**PCN# 20140212000
Design Change for VCA2615 Devices
Change Notification / Sample Request**

PCN Number:	20140212000			PCN Date:	02/13/2014
Title:	Design Change for VCA2615 Devices				
Customer Contact:	PCN Manager	Phone:	+1(214)480-6037	Dept:	Quality Services
Proposed 1st Ship Date:	05/13/2014	Estimated Sample Availability:			Date provided at sample request
Change Type:					
<input type="checkbox"/> Assembly Site	<input type="checkbox"/> Assembly Process	<input type="checkbox"/> Assembly Materials			
<input checked="" type="checkbox"/> Design	<input type="checkbox"/> Electrical Specification	<input type="checkbox"/> Mechanical Specification			
<input type="checkbox"/> Test Site	<input type="checkbox"/> Packing/Shipping/Labeling	<input type="checkbox"/> Test Process			
<input type="checkbox"/> Wafer Bump Site	<input type="checkbox"/> Wafer Bump Material	<input type="checkbox"/> Wafer Bump Process			
<input type="checkbox"/> Wafer Fab Site	<input type="checkbox"/> Wafer Fab Materials	<input type="checkbox"/> Wafer Fab Process

Sample product shipping label to indicate die rev location (**not actual product label**)

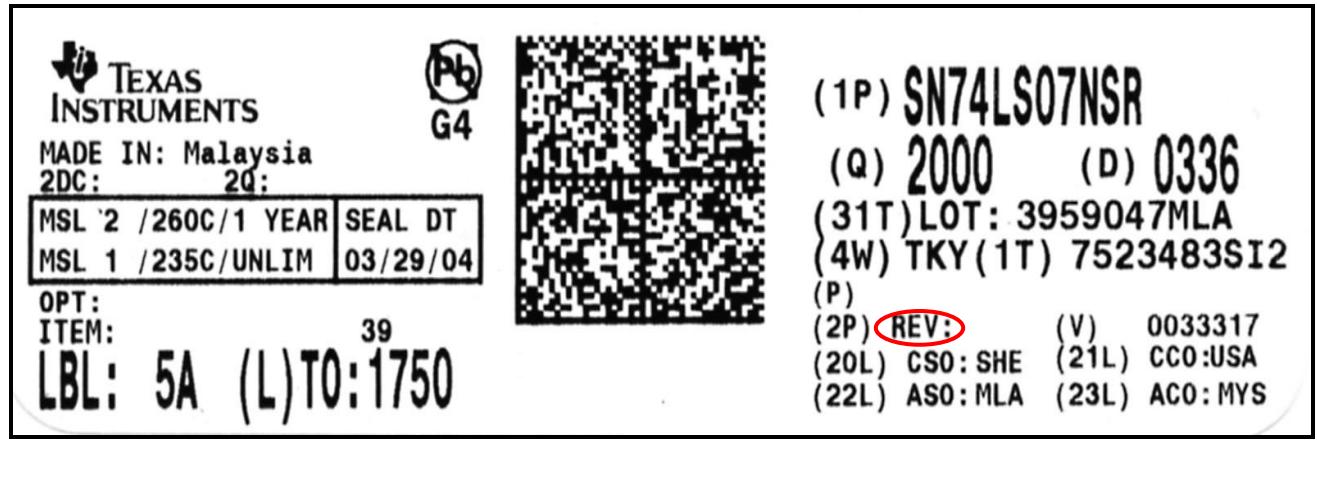
Die Rev designator will change as shown in table & sample label below:

Current	New
Die Rev [2P]	Die Rev [2P]
K	M
